DEVELOPMENT REVIEW BOARD REPORT

The Art at McDowell Mountain Marketplace

43-DR-2017

Request: Request approval of the site plan, landscape plan, and building elevations for a new, one-story, multi-tenant, commercial building, with approximately 14, 280 square feet of building area, all on a 1.5-acre parcel within the McDowell Mountain Marketplace shopping center.

Light Fixture E-1 House Shield Detail
Scale: 1" = 1'-0"

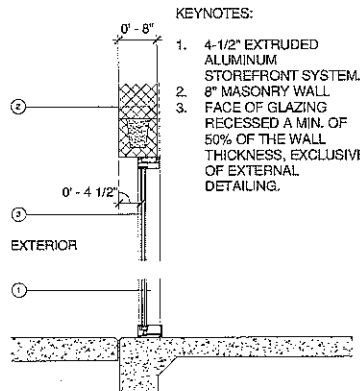
- 10. At time of final plans, the owner shall remove light fixture "E3" and replace with a light fixture that is aimed downward.
- 11. The total lumen per luminaire shall not exceed 24,000 lumens.
